Date: 27.04.2026 **Affected Models:** All Emira Powertrain 2023 - 2026 Selected Model Year VIN Range **Affected Regions:** Federal Market **Affected Volume:** 4175 **Number:** 131-26014

Fitment of tail lamp link lead harnesses to prevent rear tail lamp failure.

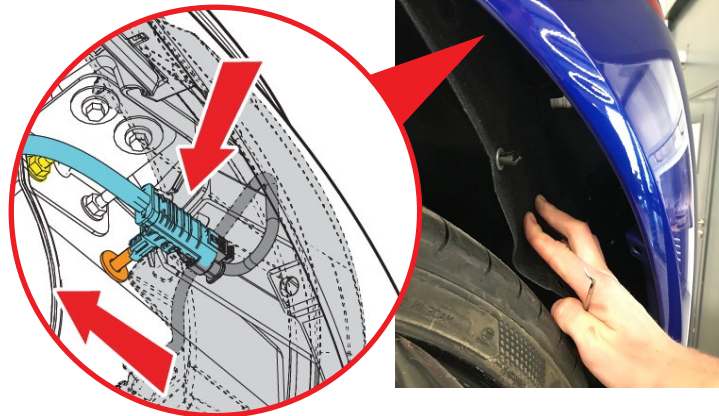
- 1.Raise the vehicle, refer to the Emira service notes, Section 0 Introduction > 15 General Information > 016 Jacking > Raise and Support Vehicle - 2 Post Lift.
- 2.Remove 1 x M6 button headed screw and 1 x scrivit securing the rear of the wheelarch liner to the rear fender as shown in the image to sufficiently pull the wheelarch liner away from the fender.

Note: It is not necessary to remove the rear wheel or the complete wheelarch liner, only liner deflection to access the harness connectors is required.

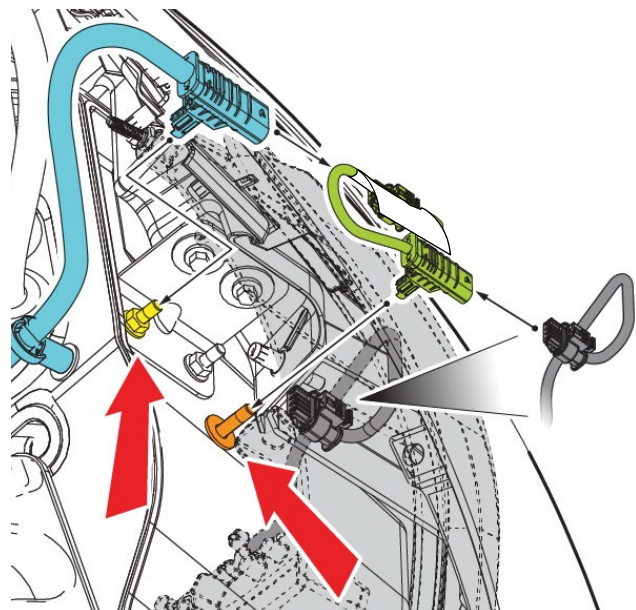
4. From the wheelarch area, pull the rear lamp to engine compartment harness connector mounting peg of from the subframe retaining stud (highlighted in orange).

5. Pull the rear lamp to engine compartment harness connector mounting peg off the fender retaining stud.

NOTE: If campaign QBS-131-26004 was already carried out, then link lead part number 8901537030 previously fitted to both sides must be removed and discarded.

7. Fit the left hand (driver side) link lead (8904408655 highlighted in green), between the connectors.

8. Fit the mounting peg of the tail lamp link lead harness onto the subframe retaining stud (highlighted in orange).

9. Fit the mounting peg of the engine compartment harness connector onto the subframe/fender bracket stud (highlighted in yellow).
